# Mona Change Request Report

Application Reference: EN010137 Document Reference: S\_CR\_2 Document Number: MOCNS-J3303-BGS-10410 15 November 2024 F02

- 1.1.1.3 The proposed changes to the Application and their rationale are set out in detail in Section 1.2. In summary, the changes are:
  - Change 1: The amendment of the proposed Order Limits to include an existing access track for temporary access during onshore site preparation works and a parcel of land to the west of the onshore substation for temporary access during onshore site preparation works and construction of the onshore substation and surrounding works;

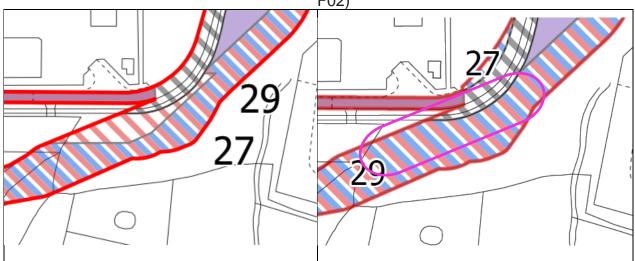
Change 2b – Amendment to Work No. 27 to widen the temporary onshore substation construction access road at grid reference SJ 01906 735519 by including a small area of additional land to the area identified for Work No. 27 (approximately 538m<sup>2</sup>) within the existing Order Limits. This land is currently identified as part of the permanent onshore substation access (Work No. 29) only.

1.2.2.4 The Applicant's preliminary design work has identified additional space is needed along the temporary construction access road in this area to facilitate the AIL's whilst ensuring adequate space for the fencing requirements outlined in the Outline Fencing Management Plan (REP2-048).

#### 1.2.3 Change 3 – Amendment of the proposed Order Limits to include additional land adjacent to the onshore substation construction access bellmouth to accommodate a temporary construction drainage attenuation basin

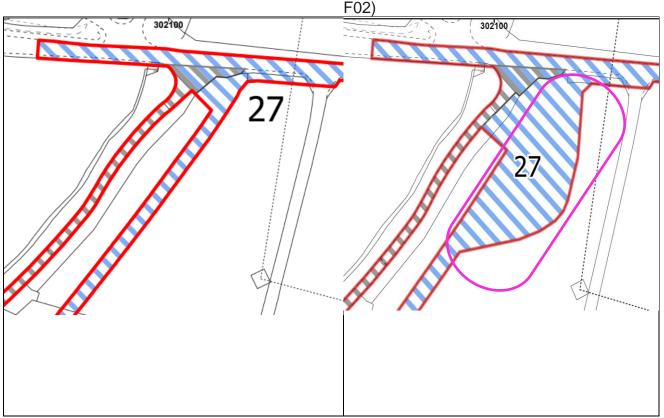
- 1.2.3.1 This change results in a widened temporary onshore substation construction access road (eastward) to accommodate an additional temporary Sustainable Urban Drainage System (SuDS) attenuation pond at the northern extent of the onshore substation construction access road.

- 1.2.3.2 The additional area of land required for Change 3 amounts to approximately 2350m<sup>2</sup>. Whilst this land was included within the Mona PEIR Offshore Wind Project Boundary published in April 2023, it was not included upon submission on the basis of the preliminary designs for the onshore substation construction access road. However, the Applicant's early detailed design works for the onshore substation construction access road, including the swept path analysis outlined in Change 2 (specifically Change 2a), have identified the need for additional land take. This is in order to deliver attenuation to control the discharge of surface water during construction, in part due to the wider road outlined in Change 2a, and also from the requirement for great crested newt fencing to be deployed, likely resulting in additional drainage pathways. It is proposed to construct a temporary SuDS attenuation basin as a measure to control this additional surface water runoff. The proposed Change 3 will result in

a controlled surface water discharge into an existing drainage channel, reducing the risk of increased flooding downstream.

# 1.2.4 Change 4 – Amendment and widening of the proposed Order Limits to include an area of land to accommodate an area of hardstanding during the construction period to allow establishment of the permanent access road

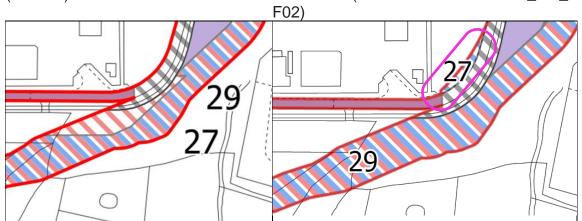
1.2.4.1 This change results in an extension of the Order Limits at grid reference SJ 01935 73551 to include the site of proposed Change 4. Proposed Change 4 will comprise a temporary area of hardstanding to be constructed immediately to the north of the existing road providing access to Bodelwyddan National Grid Substation and Gwynt y Mor Offshore Transmission Operator substation. This hardstanding will be in place during the construction period only and is necessary to facilitate the establishment of the permanent access road (Work No. 29).

- 1.2.4.3 The additional area of land required for Change 4 amounts to approximately 126m<sup>2</sup>. Whilst the land required for proposed Change 4 was included within the Mona PEIR Offshore Wind Project Boundary published in April 2023, it was not included upon submission on the basis of the preliminary designs for the onshore substation area. As with the other changes set out above, the need for the extension to the Order Limits at this location has subsequently arisen as a result of the Applicant's early detailed design works and as a consequence of ongoing landowner engagement. The landowner has expressed a preference to implement the permanent access road at the furthest possible point along the alignment of the existing access road and this change is necessary to facilitate that option. For the avoidance of doubt, despite this proposed Change 4, the Applicant needs to retain the access route optionality in this area (as shown on sheet 11 of Works Plans - Onshore (AS-003)) due to the complex nature of the constraints within these areas – utilities (including a high pressure gas main), drainage infrastructure, export cables, desire for continuity of access over the existing road, amongst others. The preferred option will be selected during the detailed design process.
